Oyster Creek Nuclear Generating Station
Renewed Facility Operating License No. DPR-16
NRC Docket No. 50-219 and 72-15

Subject: Holtec Decommissioning International's response to LTP Request for
Supplemental Information (RSI) numbers 10, 11, 12 and 13

**Response to Oyster Creek License
Termination Plan Environmental Requests
for Supplemental Information**

Figure 8.14. Survey Area and Buildings and Structures Surveyed

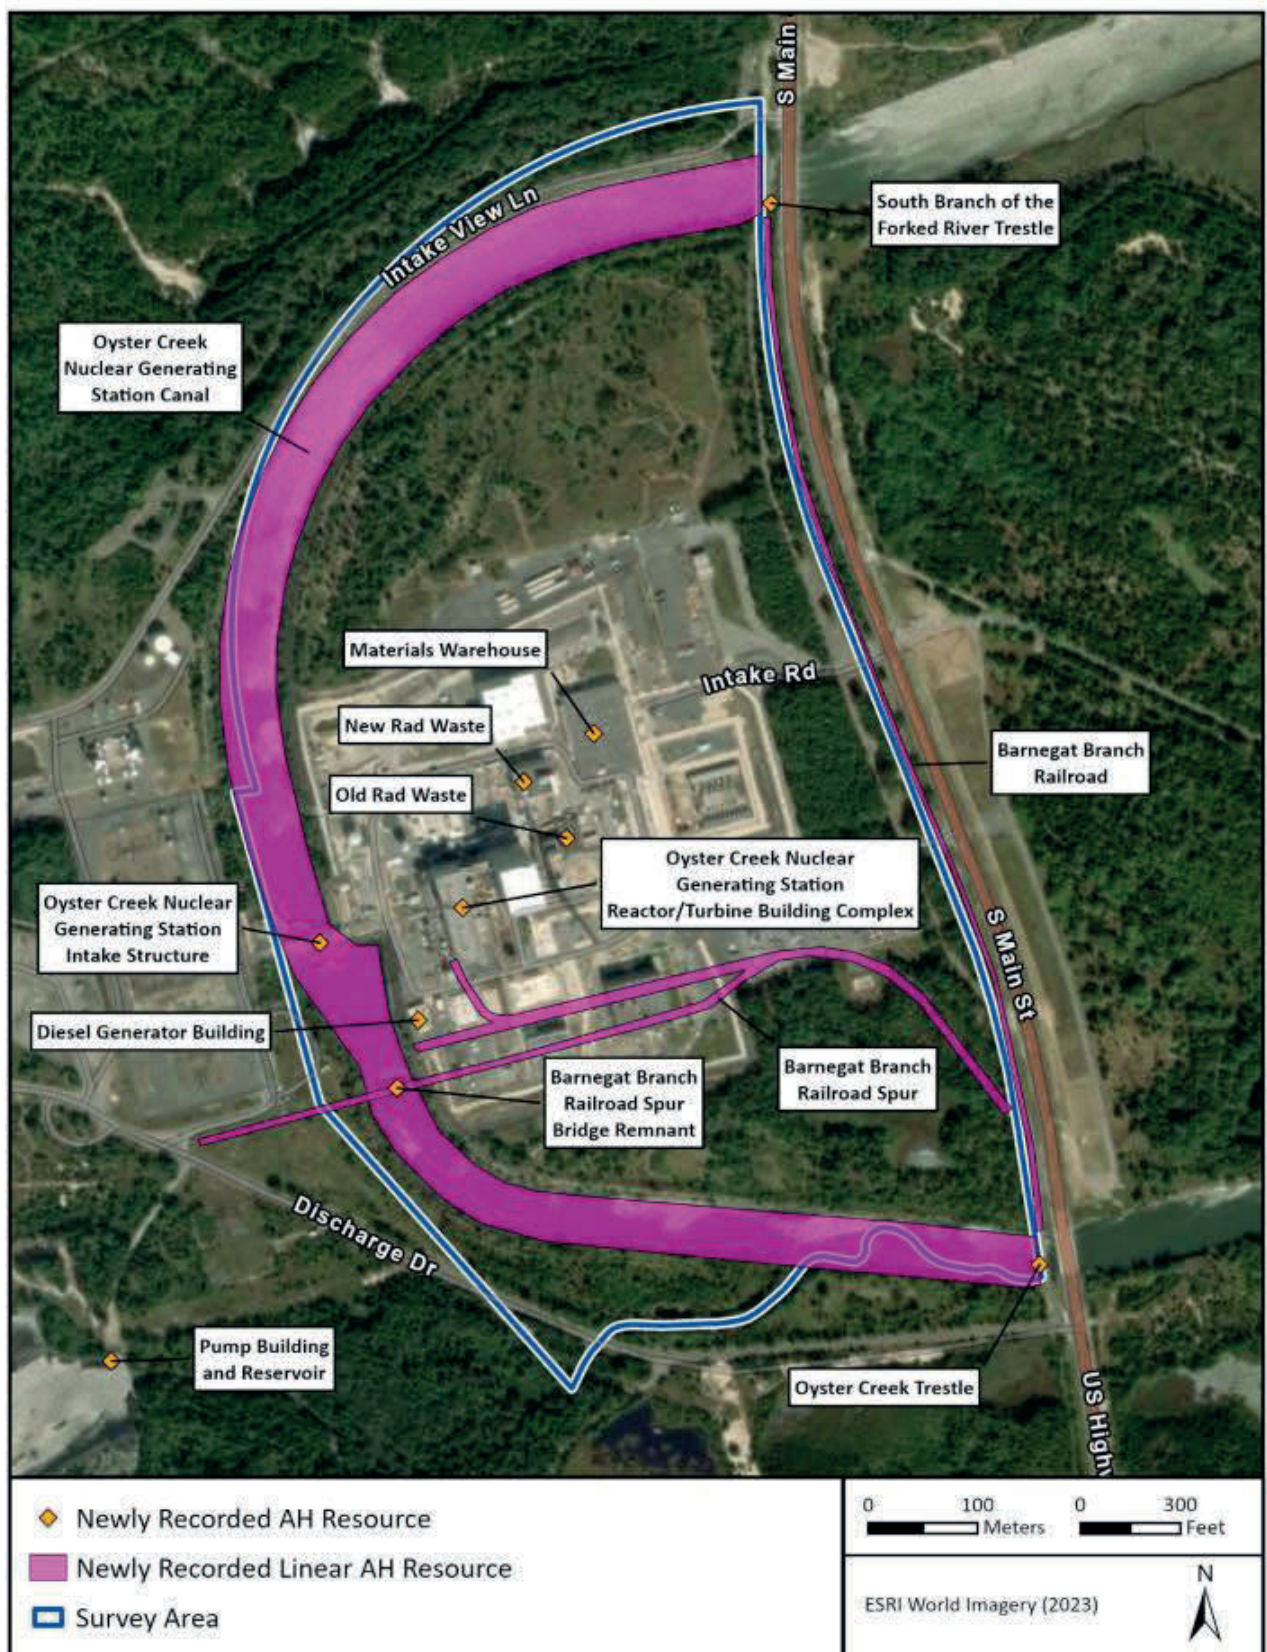
Environmental: Provide documentation of appropriate identification efforts of background research and/or field surveys meeting current state standards and provide a National Register of Historic Places (NRHP) evaluation of all potential historic properties – which include any building, structure, object, site, or district at or over 50 years of age at the time of project activities – that will be impacted by project activities.

Rationale: Based on the information provided in Section 8.8.13 of the Environmental Report, the facility may include individually eligible buildings and/or structures and may constitute a historic district. An evaluation conducted by appropriately qualified individuals (see the Secretary of the Interior's Professional Qualifications Standards and 36 CFR 800.2(a)(1)) will provide the basis for the NRC to begin consultations with all appropriate consulting parties regarding the eligibility status for the NRHP, as well as the potential effects of the undertaking on any historic properties. See 36 CFR 800.4(c) and 36 CFR 60.4 for more details about National Historic Preservation Act of 1966, as amended (NHPA) evaluations and criteria for NRHP eligibility.

Response: HDI retained SEARCH LLC to conduct an architectural survey to identify and provide National Register of Historic Places (NRHP) eligibility recommendations for aboveground cultural resources within the OCNGS licensed and immediately surrounding areas that will or could be affected by decommissioning activities. The information below has been added to Section 8.8.13 of the License Termination Plan (LTP). A reference to the report prepared by SEARCH has been added to the reference section of the chapter and will be made available to NRC upon request. The revised text of the applicable portions of the Oyster Creek License Termination Plan follows:

An architectural history survey of the OCNGS site and associated buildings and structures for listing on the National Register of Historic Places (NRHP) was conducted by SEARCH LLC in November 2024 (Reference 62). The purpose of the architectural history survey was to identify and provide NRHP eligibility recommendations for aboveground cultural resources within the OCNGS Complex. The anticipated area of potential effects (APE) for the license termination is the OCNGS licensed operational area. One structure outside the licensed area (a pump building and reservoir) that will be partially demolished as part of decommissioning also was surveyed. The buildings and structures surveyed were those constructed prior to 1980. The survey was conducted in accordance with the New Jersey Historic Preservation Office (NJHPO) *Guidelines for Architectural Survey*.

A summary of the architectural survey results is presented in Table 8.6. The Survey Area and locations of the buildings and structures surveyed are shown on Figure 8.14. A listing of pre-1980 buildings and structures demolished prior to the survey is provided in Table 8.7.
